ANN ARBOR HISTORIC DISTRICT COMMISSION

Staff Report

ADDRESS: 508 Third Street, Application Number HDC17-029

REPORT DATE: March 9, 2017

A11

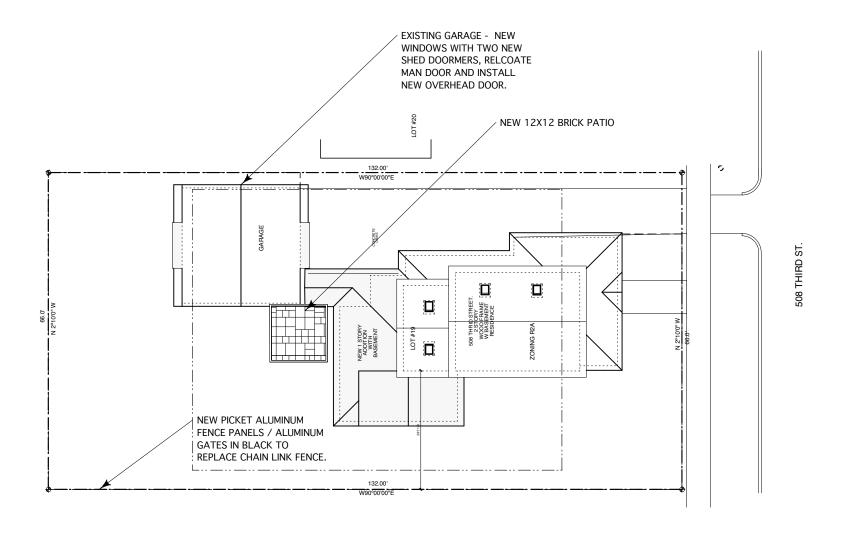
- 9. Drawing A11 shows the new black aluminum picket fence following lot lines except ending at the south side of the driveway. The location is appropriate, but no details are provided about the design or height of the fence.

- Remove the gable from the proposed addition and use a lower roof;
 - Remove the proposed new window in a new opening under the front porch roof: and
 - Provide detail on the fence design and height.
